## Schedule D1 Preliminary Landscape Plan

## NON-SUBSTANTIVE CHANGES

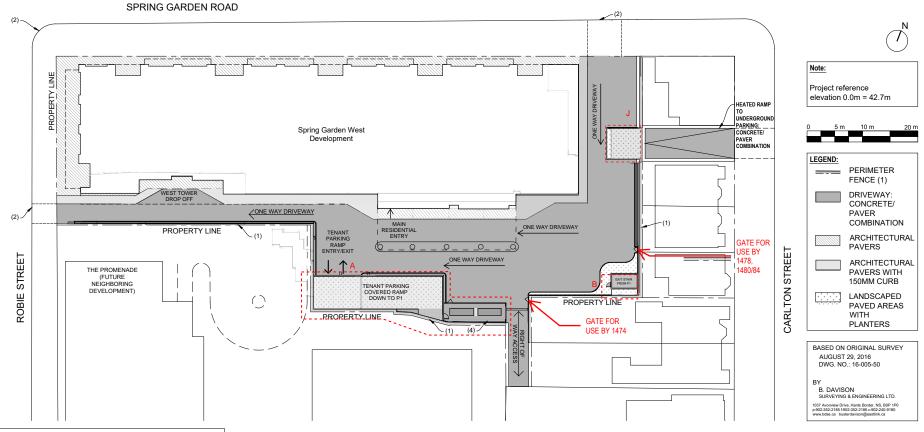
- A ADDITION OF ENCLOSED TENANT PARKING RAMP (A -141.8m<sup>2</sup>)
- B ADDITION OF ENCLOSED EXIT STAIR FROM P1 PARKING (A 14.9m<sup>2</sup>)
- C CENTRALIZED TENANT DROP OFF IN PLACE OF ENCLOSED LOADING BAY
- D WEST TOWER RESIDENTIAL ENTRY REMOVED
- E EAST TOWER RESIDENTIAL ENTRY REMOVED
- F ADDITION OF SMALL BALCONIES
- G ADDITION OF P5 PARKING LEVEL
- H BAYS EXTENED TO LOWER LEVELS
- J ADDITION OF RAISED PLANTER (HT 1.2m<sup>2</sup>)
